City of Ketchum
Planning & Building

STAFF REPORT
KETCHUM PLANNING AND ZONING COMMISSION
March 5, 2026

PROJECT: Wood River YMCA (Addition)

APPLICATION: Pre-Application Design Review

Figure 2 3D Perspective of Addition

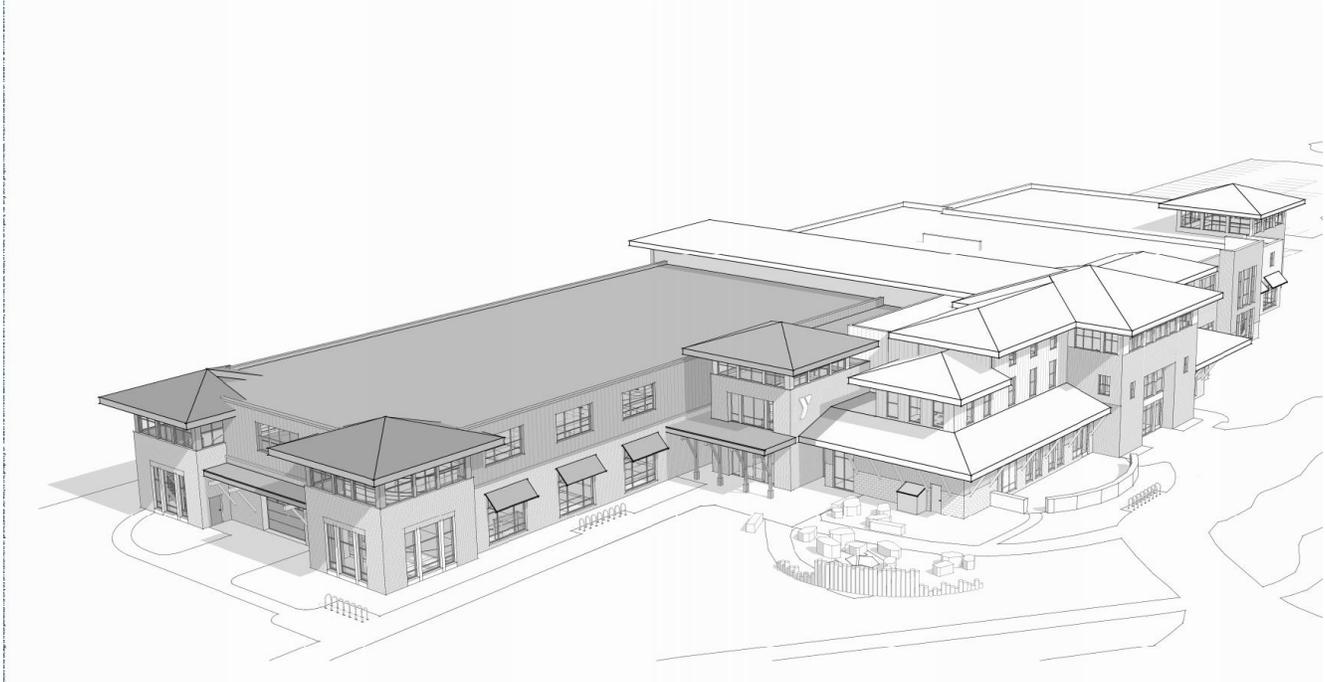
The proposed addition (See gray portion of Fig 2 below) continues the existing character as seen in the use of the same materials and color palettes. The continuation of the flat roof and three sloped roofed areas add interest within the addition and mirror the roof design existing throughout the structure.

Figure 3 Western Elevation

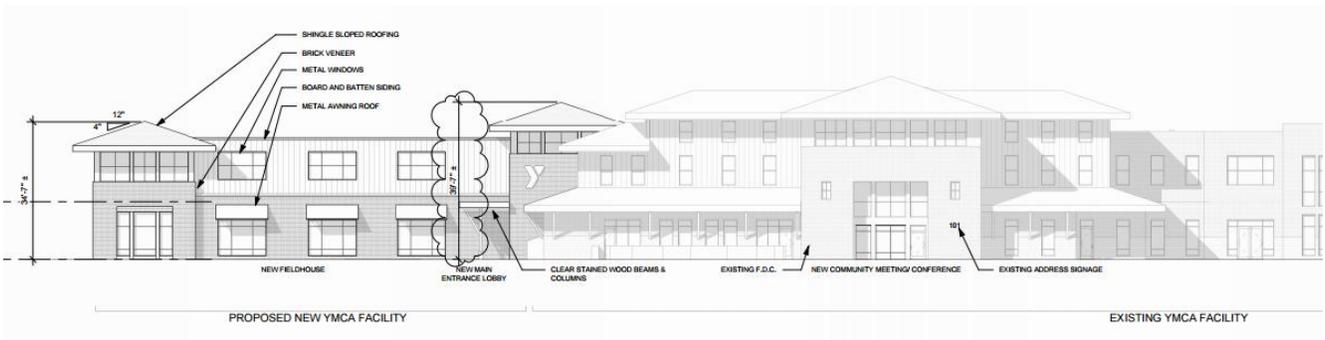
The western elevation (Fig 3) of the addition which faces Warm Spring Road has continued the design of predominate brick veneer with the hardboard on the second level. The bulk and mass is broken up by mirroring pedestrian scale awnings seen on the southern end of the building, inclusion of a variety of roof lines, and the large windows with panes to break up the flatness of the large walls. (See Sheet A.4 Building Elevations & Materials)

Figure 5: Site Plan(Sheet A1) highlighting areas to be landscaped

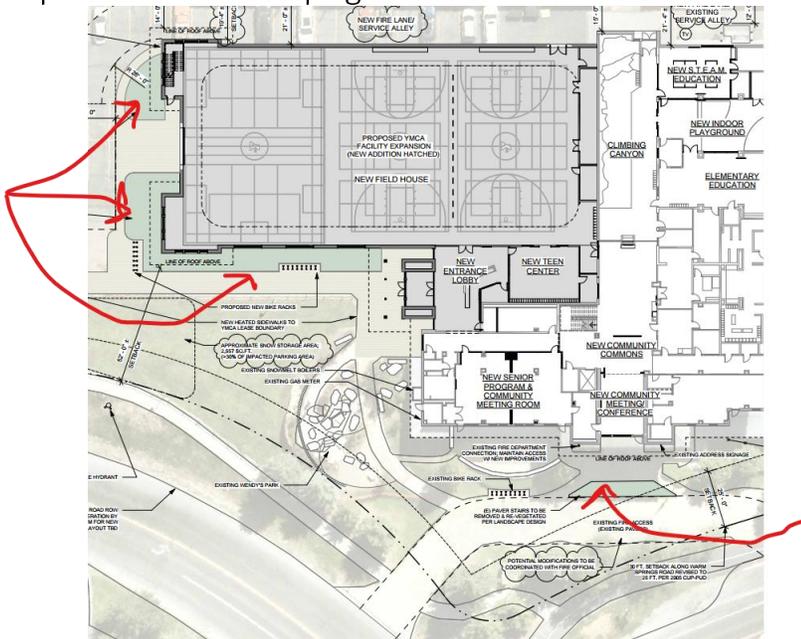
The applicant is proposing to move the existing front entrance to the northern addition creating a new front lobby. The proposal on site plan Sheet A.1 describes landscaping features to be installed to buffer the northeast and west portions of the new structure with the surrounding hardscape . New bike racks are also shown. The existing “Wendy’s Garden” will remain and is surrounded currently by permeable landscaping that also serves as 2,557sf of snow storage area. More specific

details will be required at time of design review regarding anticipated plant types and location as required in the landscaping section I: 1-4. of the evaluation standards.

COPYRIGHT © 2025
DRAWING
BUILDING ELEVATIONS & MATERIALS
DWG #

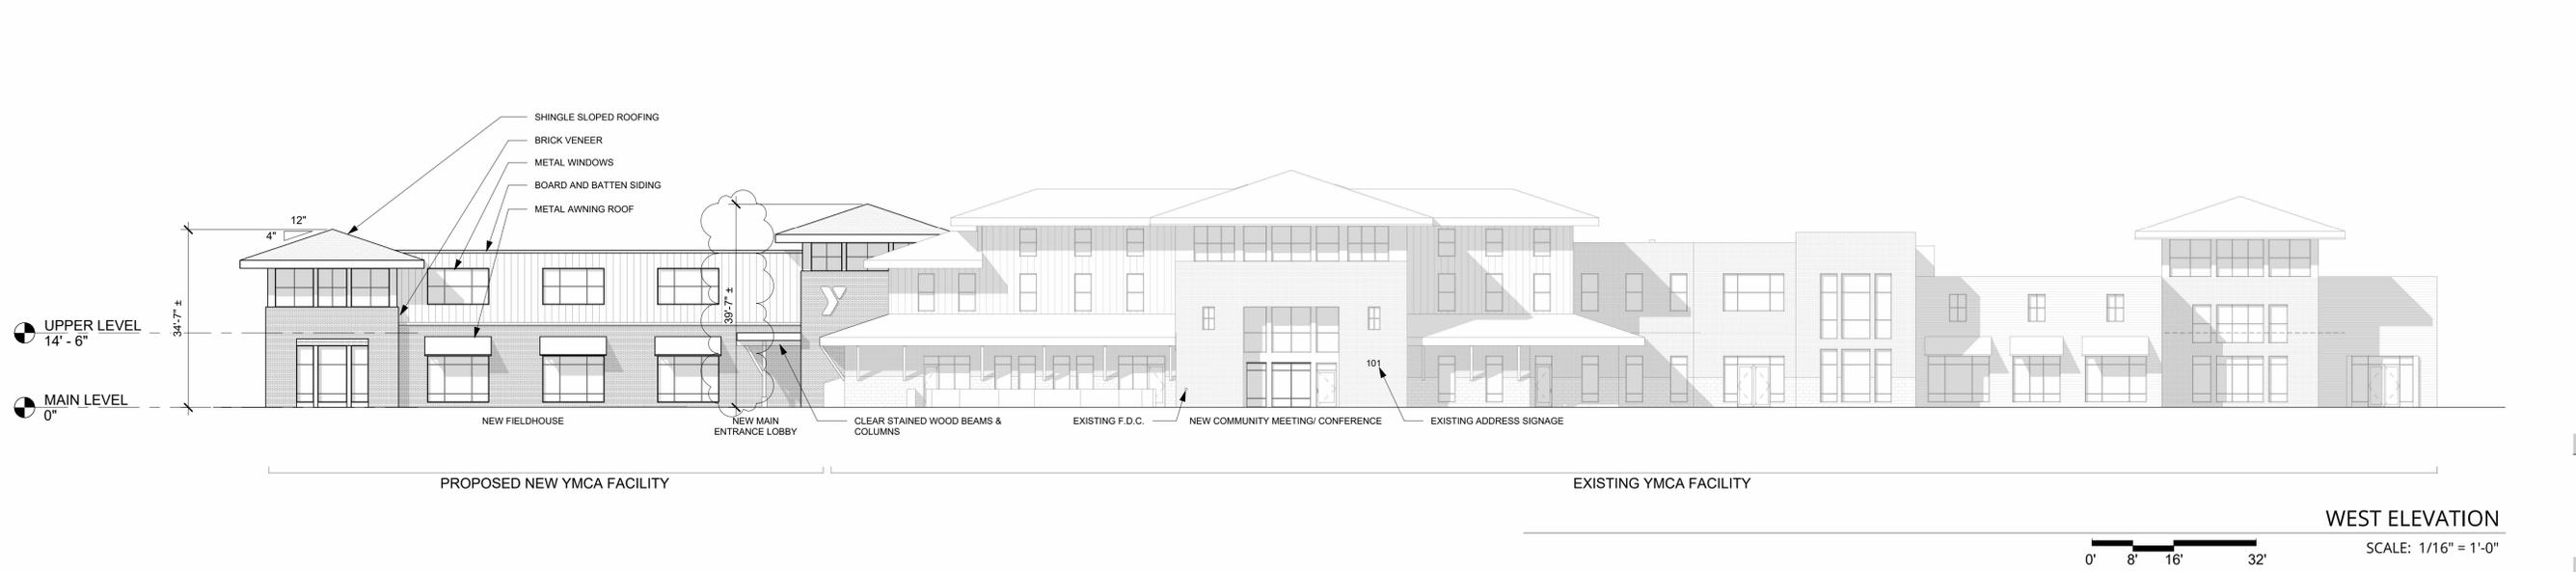
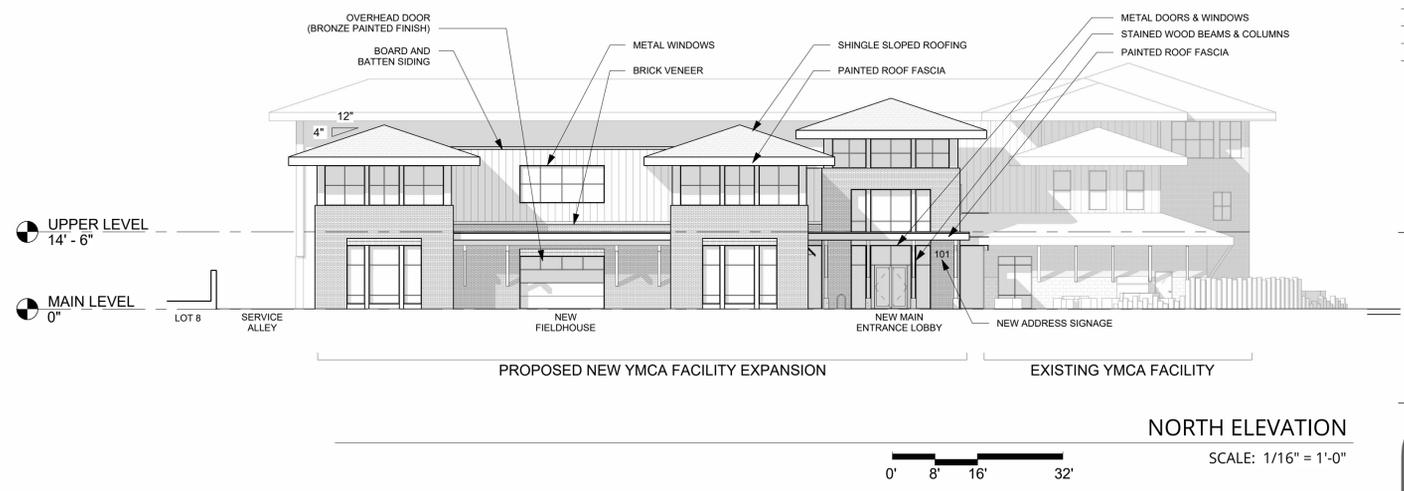
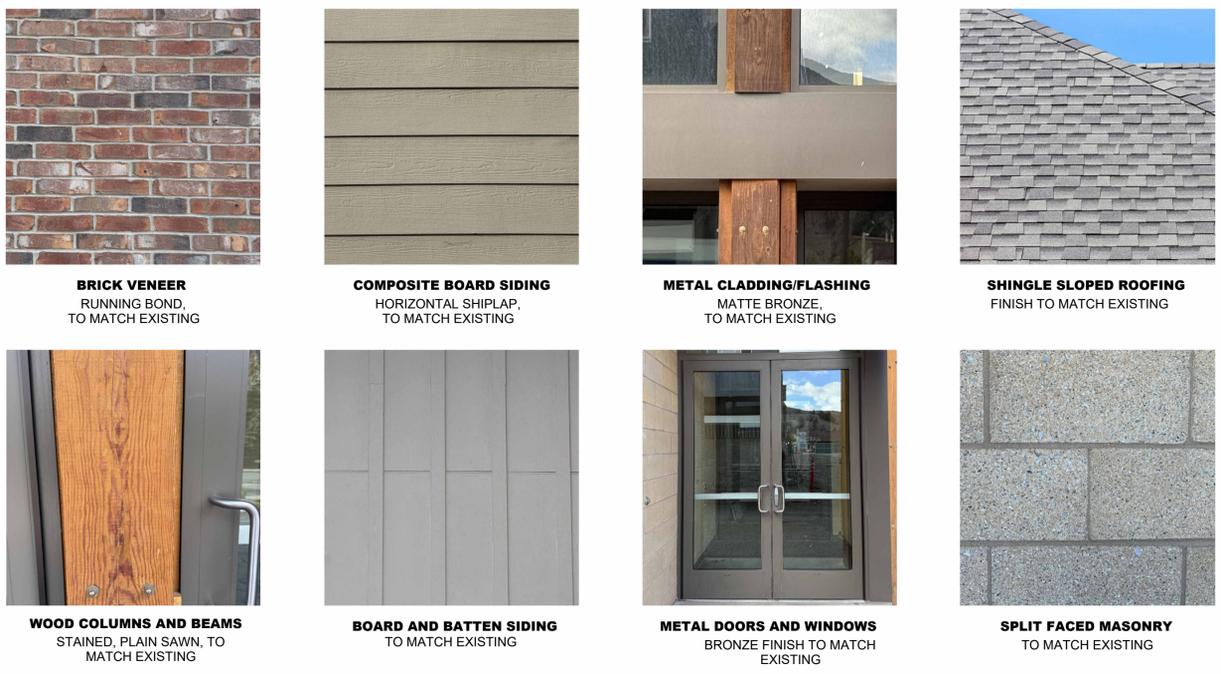
Height-The required building height per 2005 CUP-PUD is 45'6". Both proposed elevations are below the maximum height requirement.

Proposed elevations (Refer to Attachment A III. Sheet A.4):

- Northern addition of 34'7"
- West elevation lobby roof top 39'7"

1) KMC §17.96.060.E. *Compatibility of design* states; 1. *The project's materials, colors and signing shall be complementary with the townscape, surrounding neighborhoods and adjoining structures.* The materials proposed on Sheet A.4(See Image below) match the existing structural materials including the shingled roof, brick, horizontal board siding, metal finishes, wood columns and beams, masonry, board and batten, and the existing metal and glass doors. The colors of the proposed materials are designed to match the existing building therefore the addition would appear to be fully integrated into the existing architectural palate and materials. Refer to Sheet A4: Building Elevation and Materials for Specific locations of building materials.

The eastern façade is facing the service alley and matches the existing rear façade with composite board horizontal siding on the majority, split masonry on the bottom ~10, and a brick veneer building pop out. The two sloped roof lines and windows add interest and break up the large nature of the fieldhouse building.
